**ADDENDUM NO. ONE  
COMMUNITY PARK SKATEPARK LIGHTING  
PROJECT NO. 22-217**

**CITY OF THORNTON, CO**

DATE: August 18, 2023

# SITE PLAN GENERAL NOTES

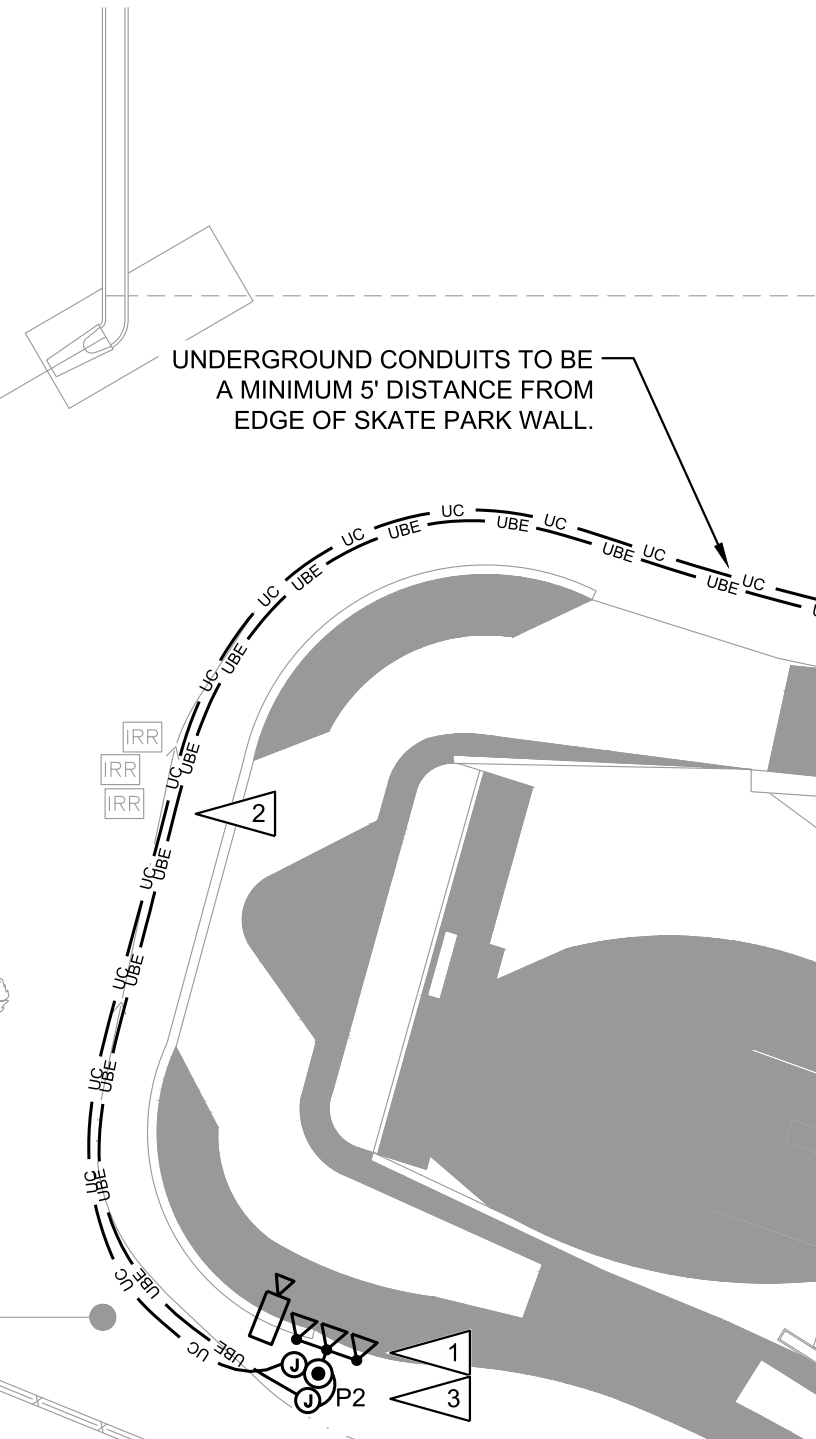
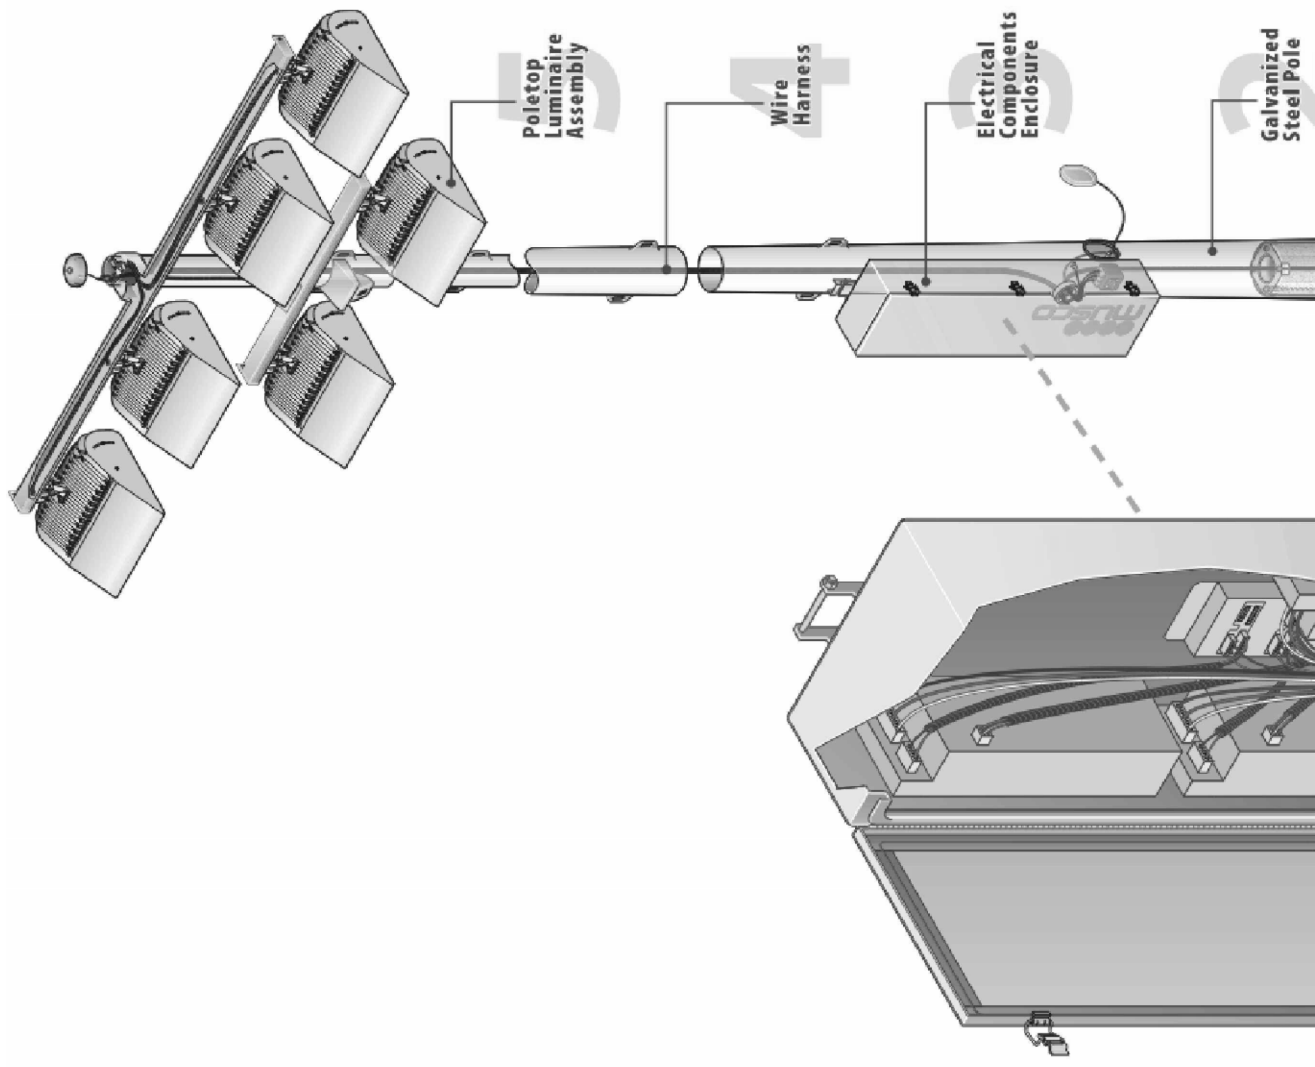
Question 1: "Are the conduit sizes identified in the drawings correct?"

Question 2: "The plans indicate "spare" conduits are to be installed. Can you please expound on the spares?"

Answer 1: The conduits for the UBE and UC lines are to be 2-Inch PVC.

Answer 2: Two 1-Inch Conduits are to be included as "spares" running from the new Hoffman enclosure to the first pull-box identified on contract drawings.
